STATE OF WASHINGTON
DEPARTMENT OF ECOLOGY

August 31, 2017

Re: Opinion on Proposed Cleanup of the following Site:

- **Site Name:** Stoneway Concrete Renton
- **Site Address:** 1915 Maple Valley Hwy, Renton, WA 98055
- **Facility/Site No.:** 62244377
- **VCP Project No.:** NW1702

Enclosure A, Figure 4

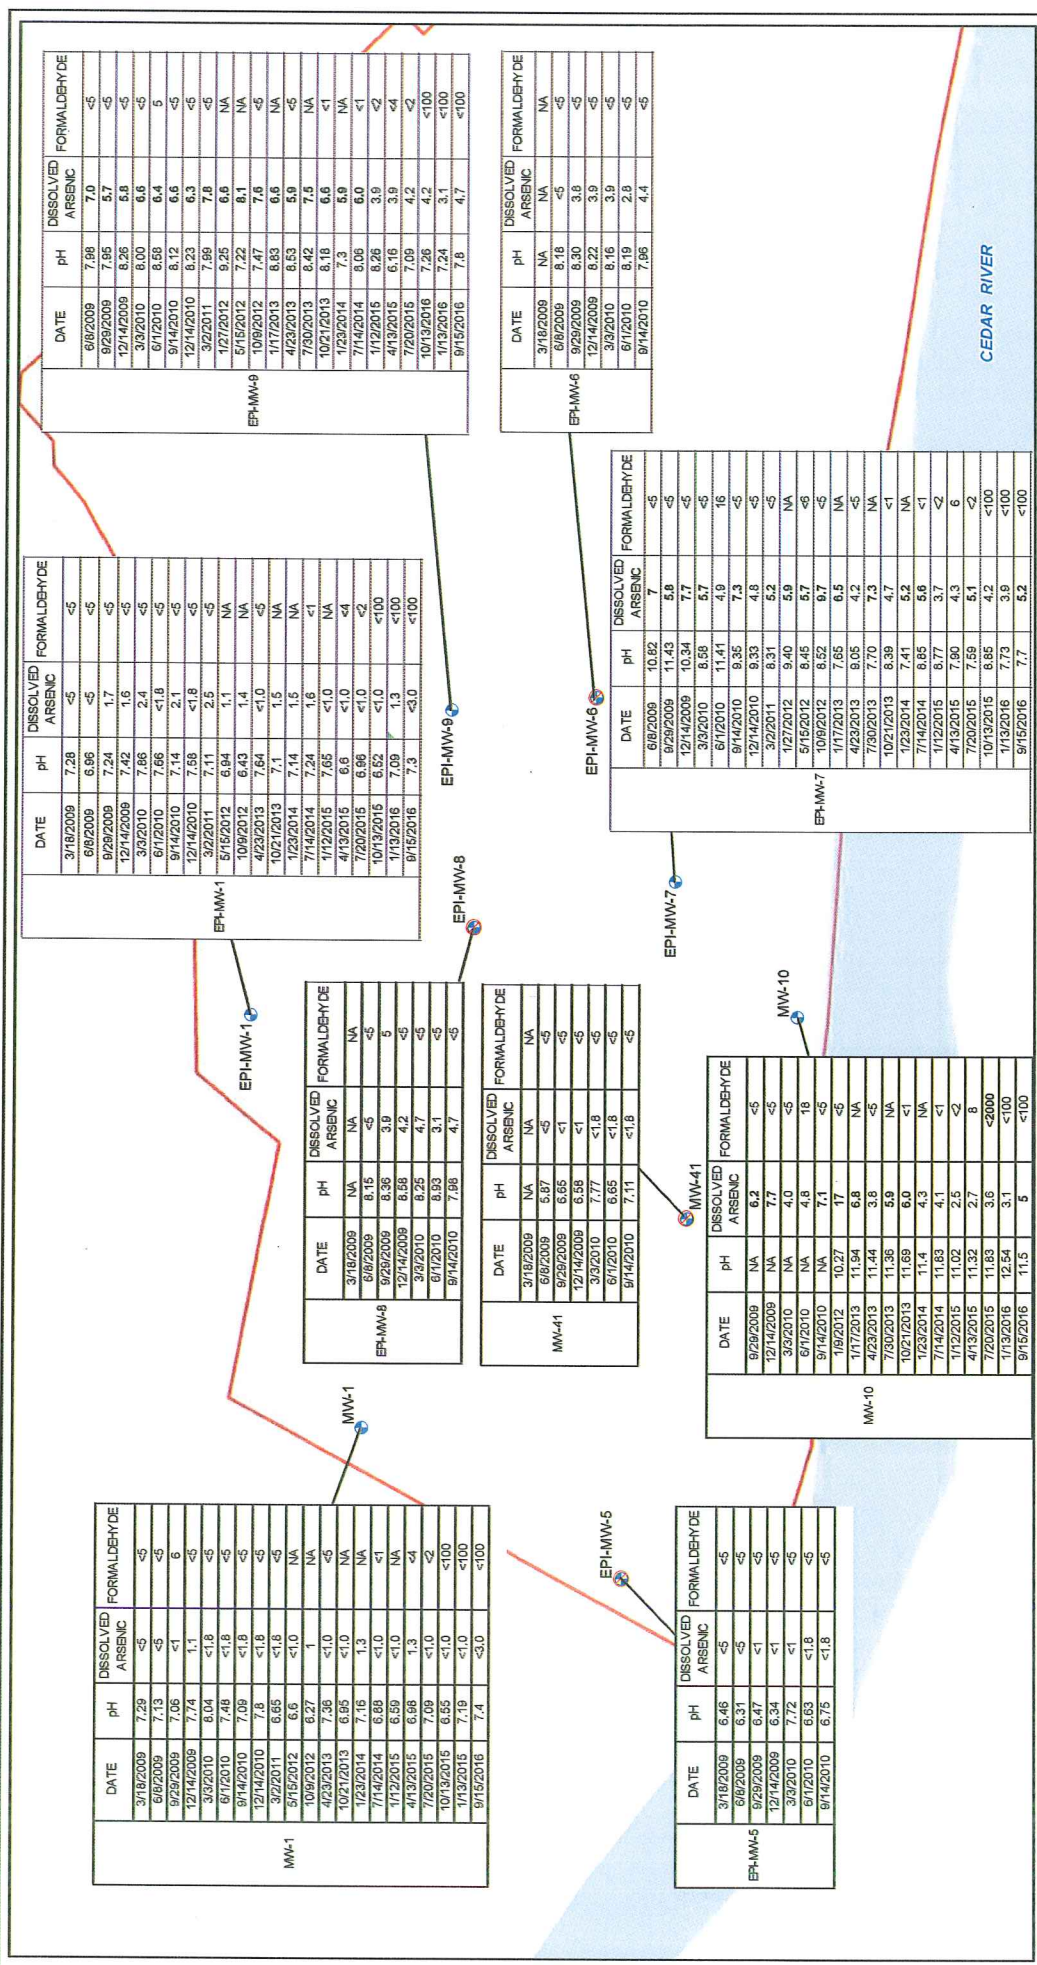
- Formaldehyde data from ground water samples collected in Site monitoring wells MW-1, MW-7, MW-10, and EPI-MW-7 are not acceptable to assess compliance with the applicable cleanup level over four consecutive quarterly monitoring events. This is due to detections above the cleanup level or because detection limits were above than the cleanup level. Per discussions at the August 2017

project meeting, Farallon agreed to check with the laboratory regarding this situation. Per the May and December opinion letters from Ecology, the Site ground water cleanup level for formaldehyde is the 5 µg/L, the practical quantitation limit (PQL). The detection limits for Site ground water samples collected since October 2015 ranged from 100 to 2,000 µg/L.

- Arsenic data from ground water samples collected in Site monitoring wells MW-10 and EPI-MW-7 are not acceptable to assess compliance with the applicable cleanup level over four consecutive quarterly monitoring events. This is the case due to detections above the cleanup level.

- The pH of ground water in the immediate vicinity of the large settling ponds along the Cedar River (as represented by monitoring well MW-10) has ranged from 11.02 to 12.54 in samples collected from 2013 through 2016. This impact, which has been attributed to residual high-pH soils beneath and adjacent to the ponds, is of concern for the following reasons:

Concentrations of COCs in ground water are shown on **Figure 5**. As mentioned in the text of this opinion letter, the present status of formaldehyde in ground water cannot be assessed, because the laboratory detection limits for the most recent sampling events were greater than the cleanup level of 5 µg/L. Elevated pH has been observed in monitoring well MW-10 since January 2012 (ranging from 11.02 to 12.54).

- Prior to collection of additional ground water samples at the Site, confirm that the selected analytical laboratory is certified by Ecology for testing of formaldehyde in water, and is capable of attaining a formaldehyde detection limit equal to or less than the Site cleanup level of 5 µg/L.
